CHANGE ESTIMATE NO. 002 Rev. 3

Project: Pflugerville Animal Welfare Services

SCOPE: Subgrade Concrete Demo / Backfill

Re: Pflugerville Animal Welfare Services Intake Kennel
1600 Waterbrook Drive
Pflugerville, Texas

FOUNDATION PLAN
SCALE: 3/8" = 1'-0"

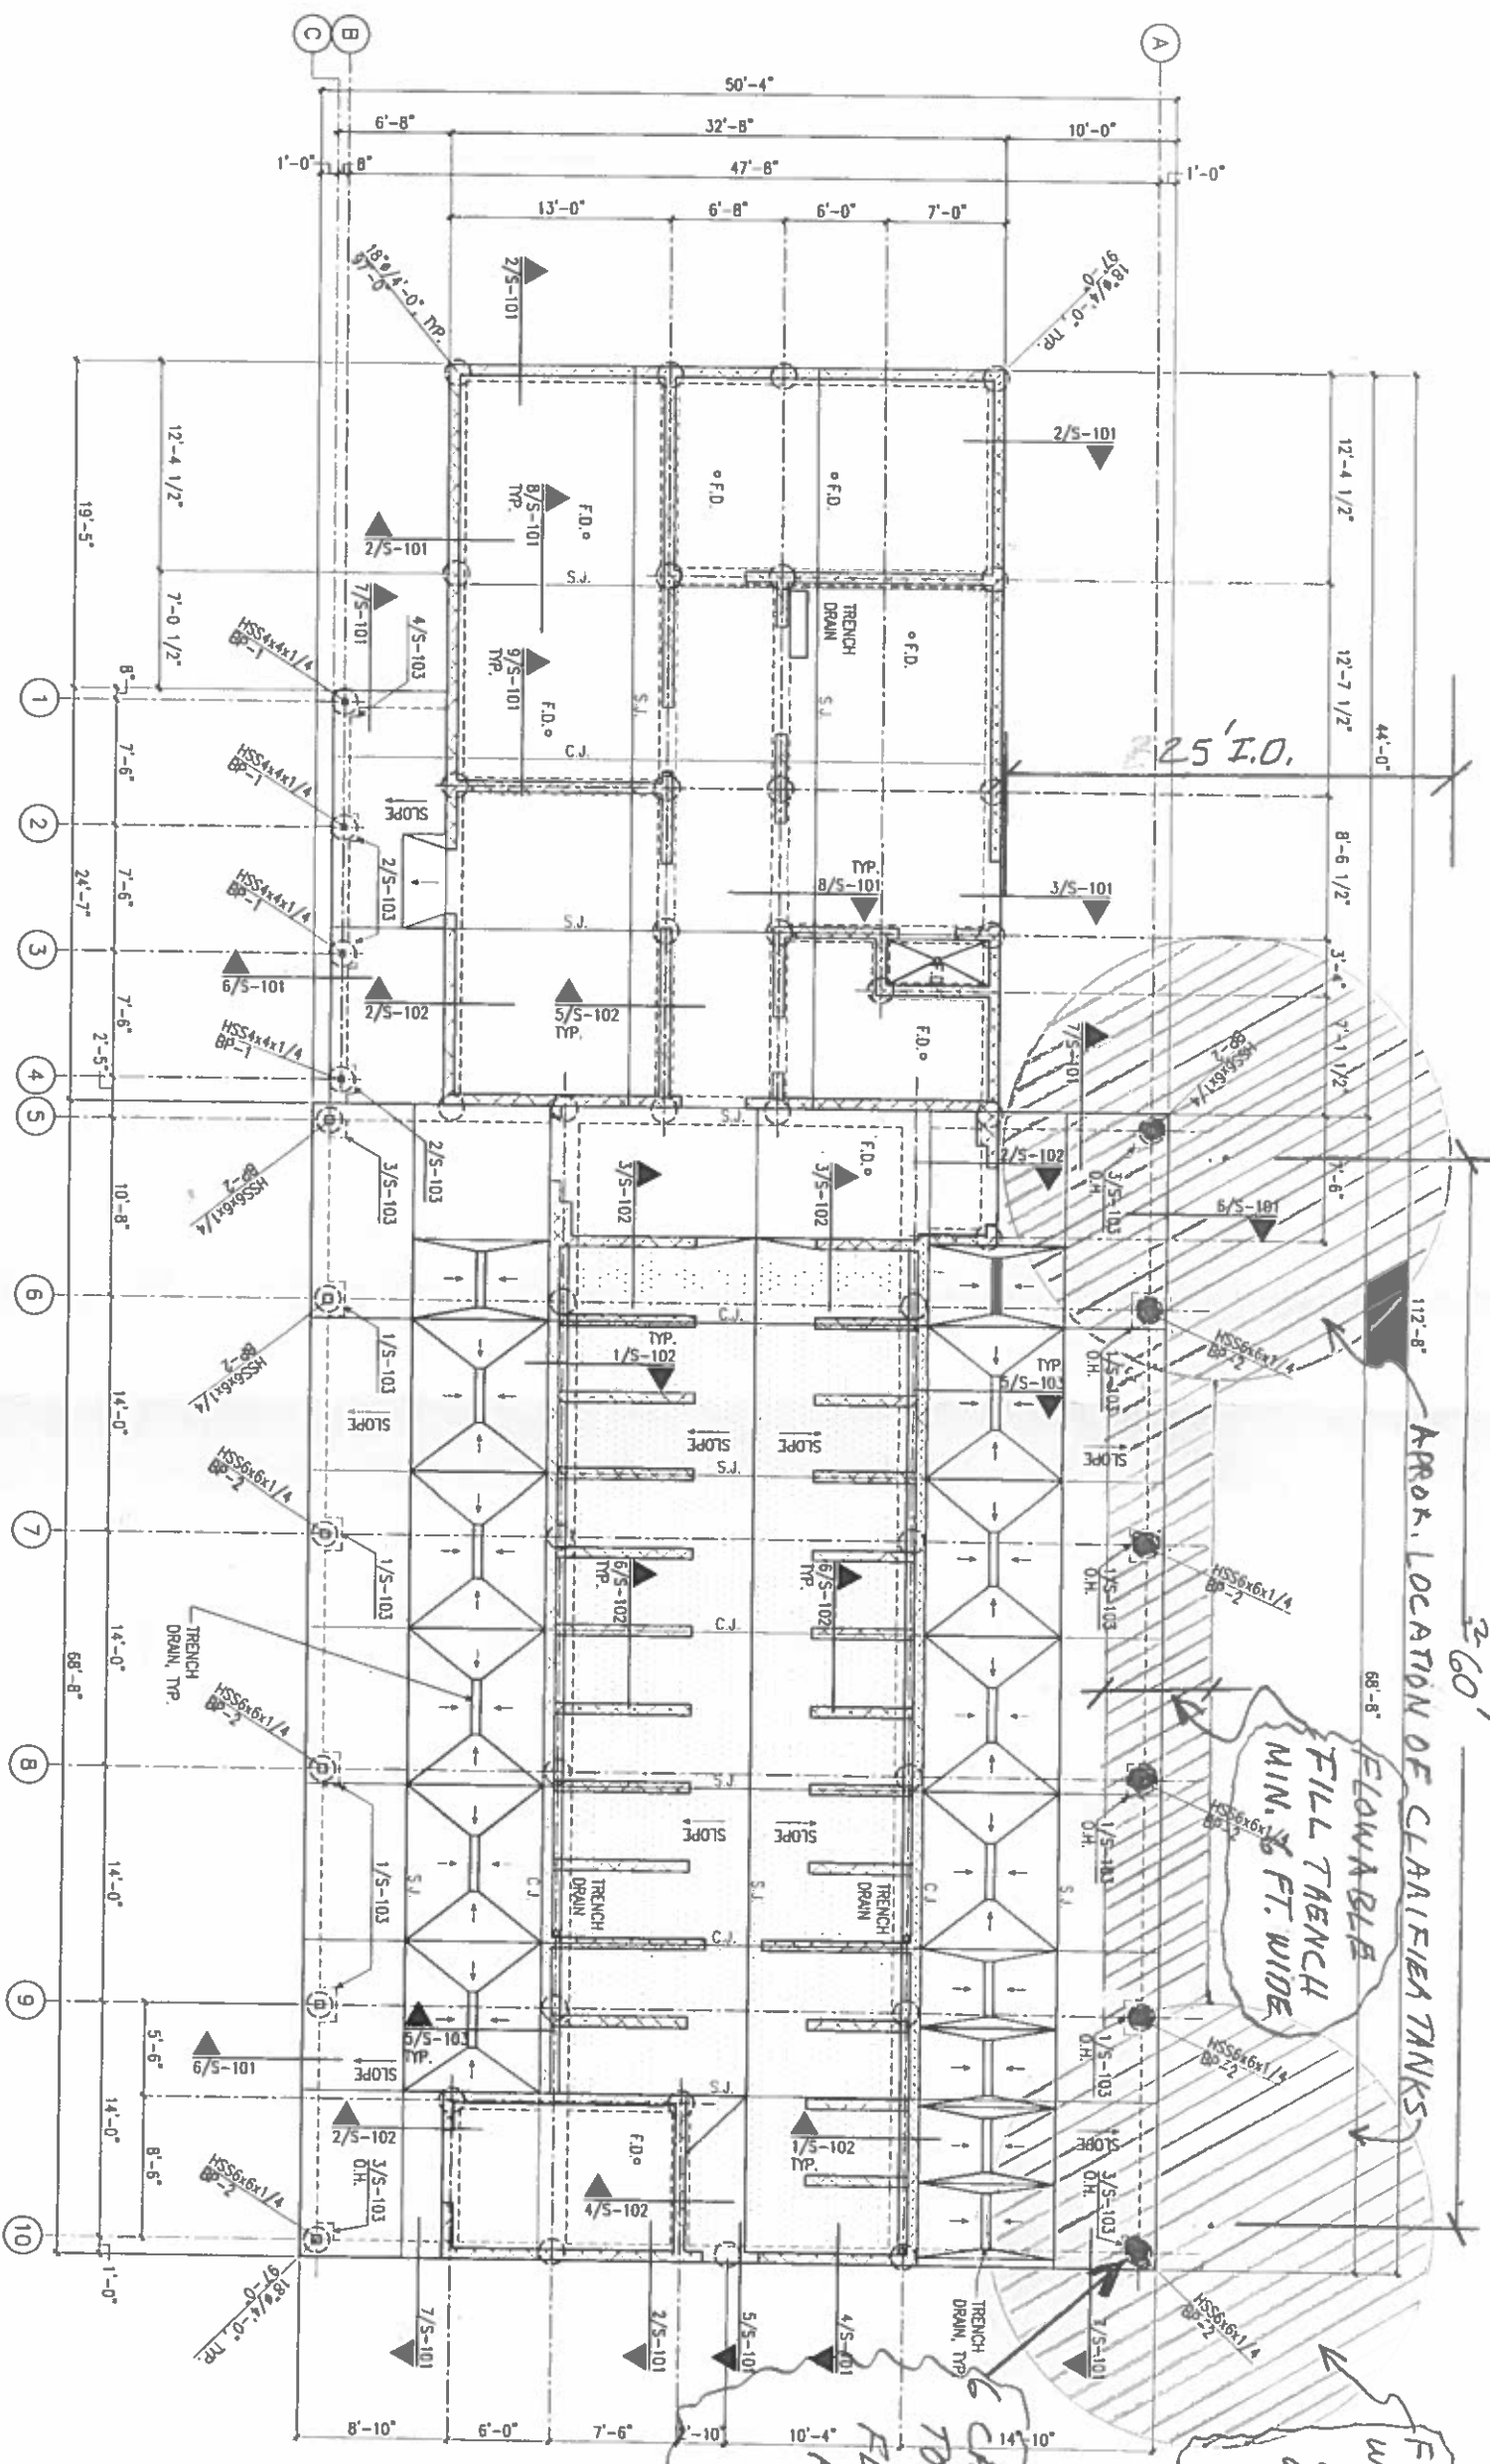
Based on field observations we recommend removing the debris in the bottom of the concrete tanks. The tank sidewalls should be removed as needed below the piers. The sides of the excavation should be sloped on about 1(H) to 1 (V) to prevent further sloughing. The water should then be pumped down to near the bottom of each, if possible. We expect a high inflow of groundwater and completely pumping all groundwater may not be possible. The tank bottom should be backfilled with about 12 inches to 18 inches of 3" x 5" diameter gravel. We expect this to be about one to two 18 yard loads of gravel in each basin. If the tanks can be sufficiently cleaned of debris and groundwater, then the gravel fill may be omitted. Each tank should then be filled with a Controlled Low Strength Fill (flowable fill with sand/cement mix) to within about 8 feet from the top of the select fill pad. The basin side walls may be left intact unless it interferes with pier placement or further excavation. We further recommend a trench approximately 6 feet wide be excavated between the two tanks along the center of the north canopy line (see attached plan) and filled with a minimum of 3 feet of flowable fill up to within 8 feet of the top of the building pad. The flowable fill should meet the requirements in Item 402S, City of Austin Standard Specifications and should have a compressive strength of 300 psi at 28 days. The flowable fill should be allowed to set for at least 48 hours before backfilling with the select fill for the building pad. The select fill for the building pad (as per plans) should then be placed in 8 inch lifts over the flowable fill section. We recommend all 6 piers on Grid Line "A" supporting the canopy be drilled to a

depth of 8 feet and bear on the flowable fill. We recommend the allowable bearing value for the piers to be the same as we provided in the original geotechnical report (3,500 PSF) so no change in pier size is expected. Please have the structural engineer review and approve. We have attached a preliminary drawing showing the approximate tank locations and the trench between the tanks to be filled with flowable fill. The attached plan is subject to the Architect and Structural Engineer approval.

APPROX. LOCATION OF CLARIFIED TANKS

FLOWABLE FILL TRENCH MIN. 6 FT. WIDE

FILL TANKS W/FLOWABLE FILL TO WITHIN 8 FT OF PAD SURFACE

FLOWABLE FILL APPROX. 8' BELOW TOP OF PAD

CANOPY PIERS TO BE BORN ON FLOWABLE FILL APPROX. 8' BELOW TOP OF PAD

PRELIMINARY REMEDIATION PER HOLT ENGINEERING 2-6-2018 (NOT FOR CONSTRUCTION)
